RAINFOREST RECOVERY CENTER DETOX ADDITION Contract No. BE19-173

ADDENDUM NO.: FIVE

April 26, 2019

A503

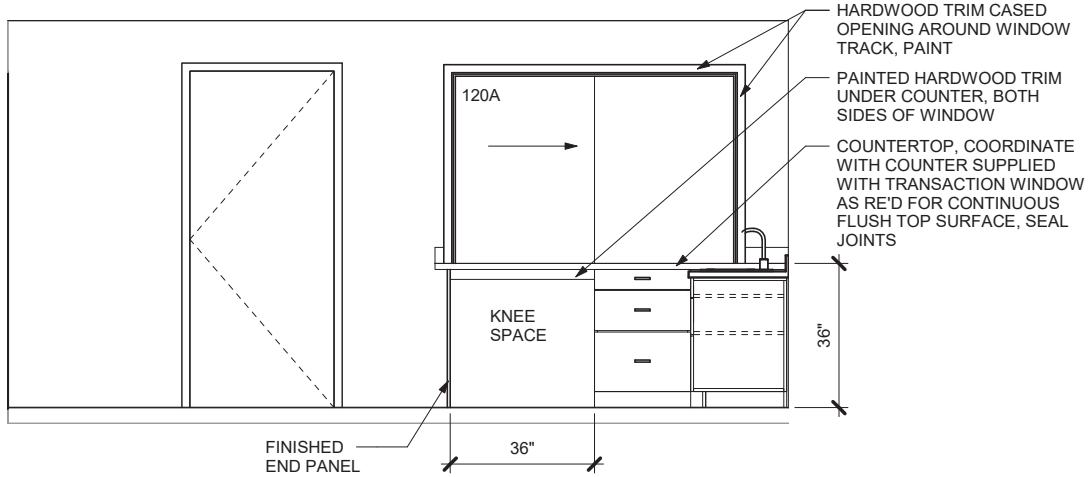
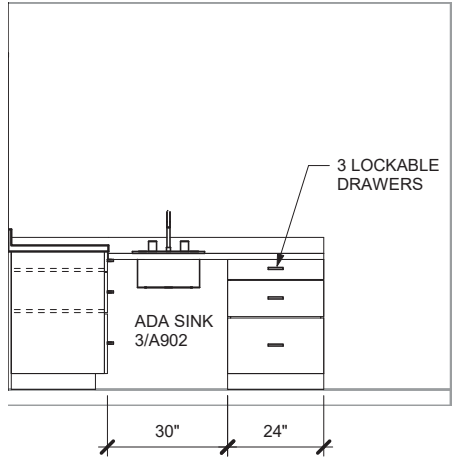
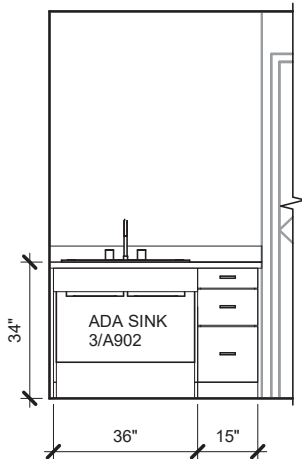
- Item No. 1: Drawing 2/A403 – ALTERNATE 2 - PLAN, **add** an interior elevation callout at the sink and counter shown in Activity 140 which reads, “4/A503”
- Item No. 2: Drawing A503 –INTERIOR ELEVATIONS, **modify** drawing as per the attached.
- Item No. 3: Drawing M003 –SCHEDULES, **modify** drawing as per the attached.
- Item No. 4: Drawing M601 –LARGE SCALE MECHANICAL & FAN ROOMS, **modify** drawing as per the attached.
- Item No. 5: Drawing M602 –MECHANICAL ROOMS 123A SECTIONS, **modify** drawing as per the attached.
- Item No. 6: Drawing M603 –FAN ROOM 153 SECTIONS, **modify** drawing as per the attached.
- Item No. 7: Drawing M702 –LARGE SCALE DETOX AREA - HEATING, **modify** drawing as per the attached.
- Item No.8: Drawing M801 –HEATING DETAILS AND DIAGRAMS, **modify** drawing as per the attached.

1 TEMPERED HEATING WATER DIAGRAM

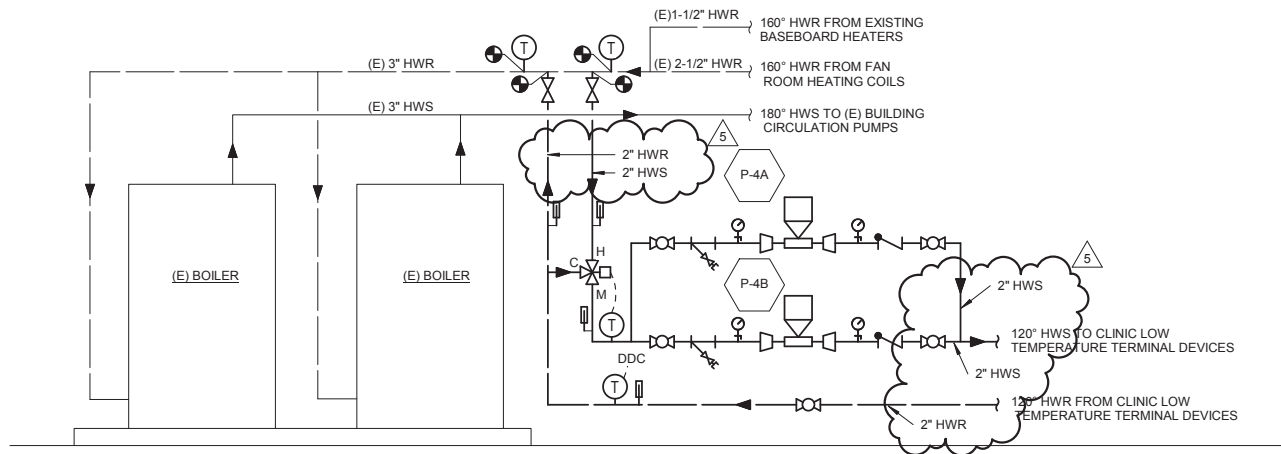
Question 4: "Section 23096.1.3.A.3. States The Work includes installation of a new controls interface for the 2 existing boilers and associated hydronic heat pumps (5). No sequence of operations was provided for the existing boilers. Also, Detail 1 on M801 displays a 3-way control valve and temperature sensors. Will the control valve remain as existing or be replaced?"

Question 5: "Will the contractors be provided with a sequence of operations for the control valve and existing boilers?"

Response 4: See Project Manual Item No. 8 in this Addendum .The 3 way control valve is a new control valve.

- Item No. 9: Section 230926 – BUILDING AUTOMATION SYSTEM AND AUTOMATIC CONTROLS, 3.8 SEQUENCE OF OPERATIONS, **add** a new paragraph G to read:
“THREE WAY MIXING VALVE: Modulate three-way temperature control valve to maintain a supply water temperature of 140 Degrees F (adjustable)”
